28 Redington Road - 2019/6407/P

Delegated Report (Members Briefing)		Analysis sheet		Expiry Date:	24/03/2020	
		N/A		Consultation Expiry Date:	02/03/2020	
Officer			Application N	lumber(s)		
David Peres Da Costa			2019/6407/P			
Application Address			Drawing Numbers			
28 Redington Road London NW3 7RB			Refer to Draft Decision Notice			
PO 3/4	Area Team Signatu	ire C&UD	Authorised O	fficer Signature		
				_

Proposal(s)

Replacement of north-westerly extension including new windows at ground floor on northwest elevation; alteration and enlargement to south-eastern wing to include first floor extension; rebuild and extend rear extension to include lantern rooflight; enlargement of 2nd floor including raising height of rear gable, erection of two dormers and rooflights to north west elevation; removal and relocation of chimneys; solar panels to rear roof and glazed balustrade to 3rd floor roof terrace; alteration of front porch including limestone finish and alteration to front steps and door; excavation of lower ground floor level to lower by 0.5m and excavation of front lightwell; alterations to windows, ground floor bay and erection of balcony at first floor level, all on the rea

Site photos

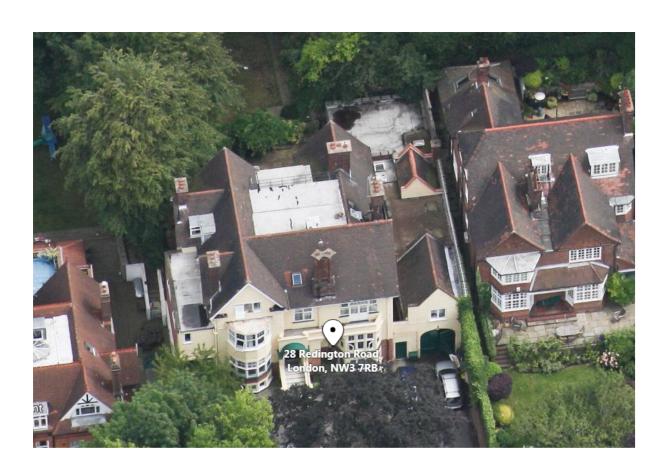
2. View of north westerly extension to be demolished and rebuilt

4. View towards rear extension which would be demolished and rebuilt
